# Work Order ID 94883

Item Name: Crosstube Turning Detail

DRAWING NO. D212-664-241	TITLE CROSSTUBE ASSY (205/212 HI AFT)	REV. D	DART AEROSPACE LTD ENGINEERING ORDER		D.E.O. NO. D212-664-241-D-1	SHEET NO. SHEET 1 OF 2	SCALE NTS
DRAWN	CHECKED	MFG. APPR.	APPROVED	DE APPR.			
DATE 11.04.07	DATE 11.04.11	DATE 11.04.12	DATE 11/04/12	DATE 11.04.12

ADD AN INSPECTION WINDOW TO UNDERSIDE OF CROSSTUBE.

**D212-664-241/-241B  
ASSEMBLY DETAIL**

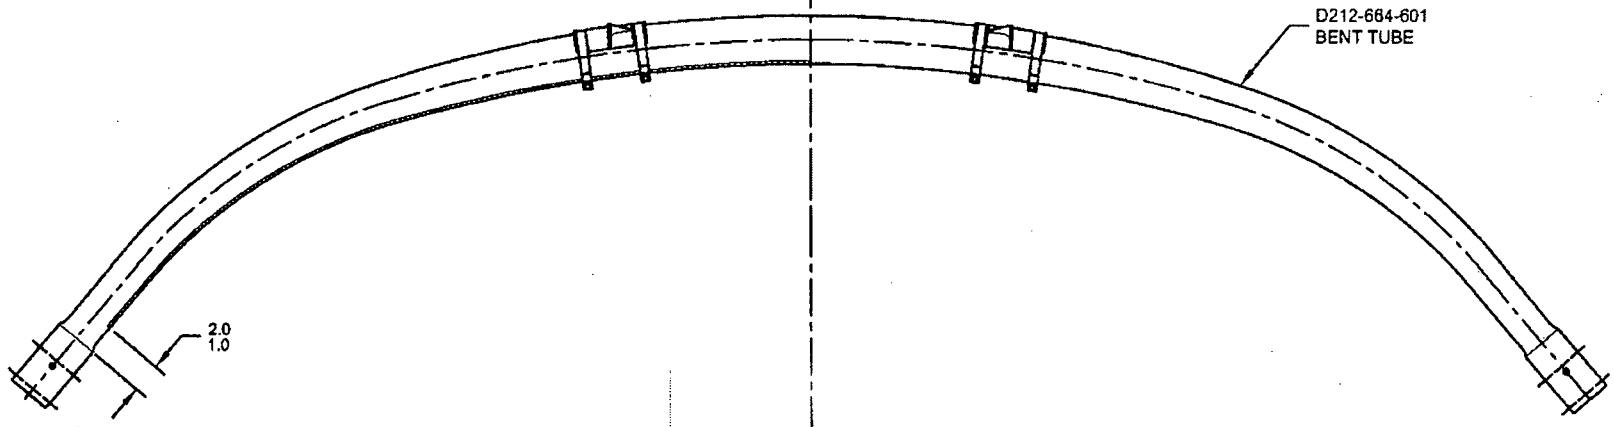
IS:

WAS:

MASK AREA PRIOR TO PAINTING,  
REMOVE MASKING AFTER PAINT  
AND APPLY CLEAR COAT
